NUCLEAR REGULATORY COMMISSION

Title: Advisory Committee on Reactor Safeguards

Plant License Renewal Subcommitee Prairie Island Nuclear Generating Station

Date: Tuesday, July 7, 2009

Refueling Cavity Leakage Containment Design

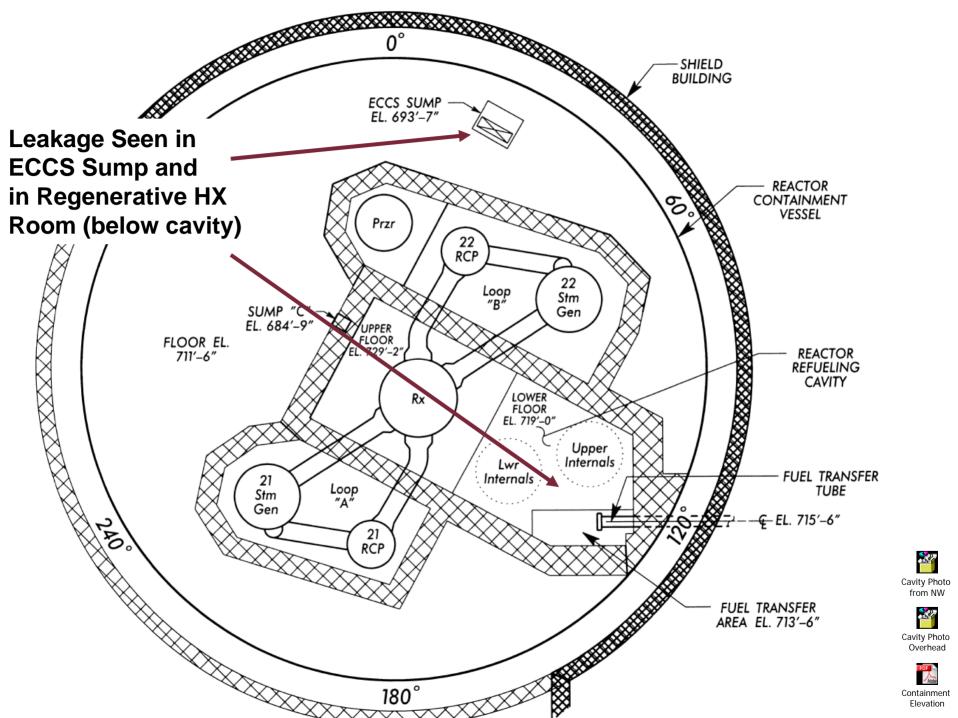
Actually, if you turn to the last slide in your presentation -- we did include a figure so we can look at that. The containment pressure vessel itself has an inch and a half thick bottom head, an inch and a half thick shell, and the top head is 3/4 of an inch thick.

The lower head, as you can see in the drawing, is fully encased in concrete on both sides. The remainder of the containment pressure vessel -- and there's a five foot annular gap between the containment vessel itself and the one in the leakage -- reinforce the concrete shield building. That allows us access to the vast majority of the containment pressure vessel itself.

Refueling Cavity Leakage Leak Locations

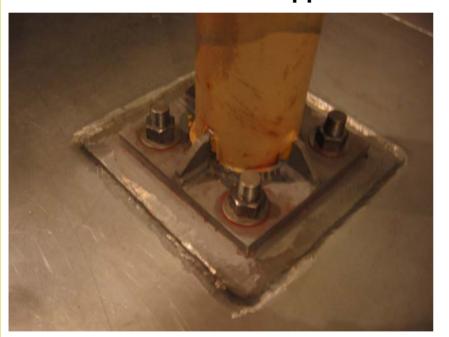
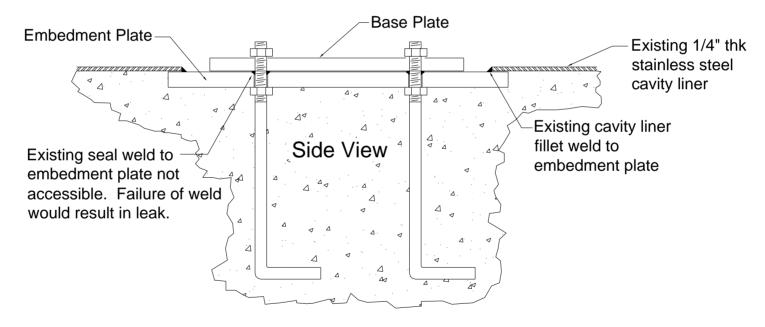
As a result of that root cause evaluation, we determined the sources of leakage to be the embedment plates for the reactor internal stands which are in the lower cavity and then the rod control cluster change fixture supports which are in the transport.

The leakage, we believe to be flowing the threads down past the nut. Once past the nut, there's a seal weld -- this is the RCC change fixture -- seal weld that was installed when this was originally put in.

MR. SKOYEN: Yes. Past actions that we've taken, most recently was caulking and we would remove the nuts from the top of the base plate, underneath those nuts to prevent the leakage from going past the threads. Then between the base plate and the embedment plate, we would try to caulk there.

and installation in that area. What we're performing now is a permanent repair so that we don't have to do that anymore. MR. WADLEY: It's not acceptable to continue to have this leak. Too many unknowns. CHAIRMAN RAY: Mike, I must say that that was hard to figure out from a lot of the rhetoric that was submitted here -- that it wasn't acceptable. 8 I'm glad to hear you say that. 10 MR. BARTON: Yes, thank you. MR. SKOYEN: The repair method that we're 11 12 going to employ is shown on this particular slide. As 13 you can see, on the right hand side of the slide is the existing configuration with an open nut. 14 We will be installing blind nuts, as 15 16 noted on the lefthand side in the particular 17 locations where it's attainable to surface area and 18 the thread engagement. 19 Then putting a seal weld all the way around the location, that will eliminate the leak 20 21 path that could occur there. 22 We'll also be putting a seal weld between 23 the base plate and the embedment plate to eliminate that leak path. 24 25 We believe that by doing this, we will

permanently eliminate the leakage that occurs from both the internal stands and the RCC change fixture support stands. MEMBER ARMIJO: There was no seal weld there initially? MR. BARTON: There was initially. said down here, they think that --8 MEMBER ARMIJO: Yes, just around the threads. 10 11 MR. SKOYEN: Yes. Just around the threads. 12 So we believe this to be a much more 13 robust design than was the original. It also allows us to inspect these welds going forward and identify 14 15 any concerns with those in repair. 16 It also, from a dose consideration, 17 perspective, is we receive far less dose employing 18 this method of repair than going back to the original 19 drawing. 20 So for a number of reasons, we believe 21 this is the correct method for repair. 22 CHAIRMAN RAY: I take for granted that 23 there aren't any leak chases on the seams of the cavity and so on. 24

ECCS Sump Showing Grout

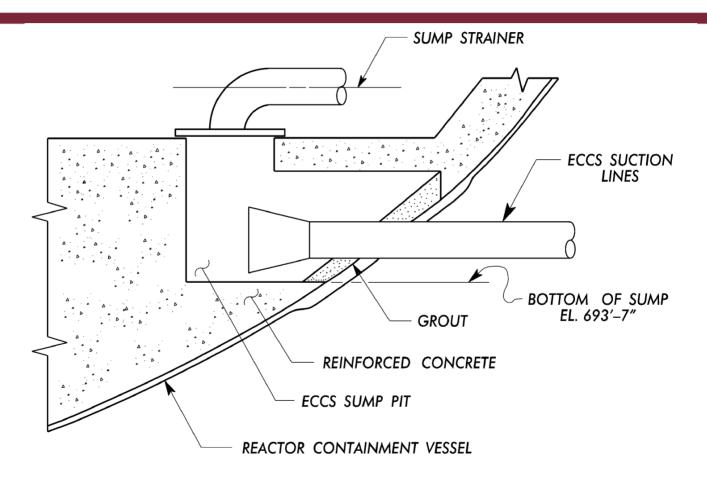
MR. SKOYEN: Correct. Regarding inspections that we've done related to the leakage, we have poured ultrasonic examinations and visual examinations of the containment vessel.

UT exam of containment vessel from annulus was performed. Scanned 18' long x 2' high area with all readings above 1.5 inch nominal plate thickness.
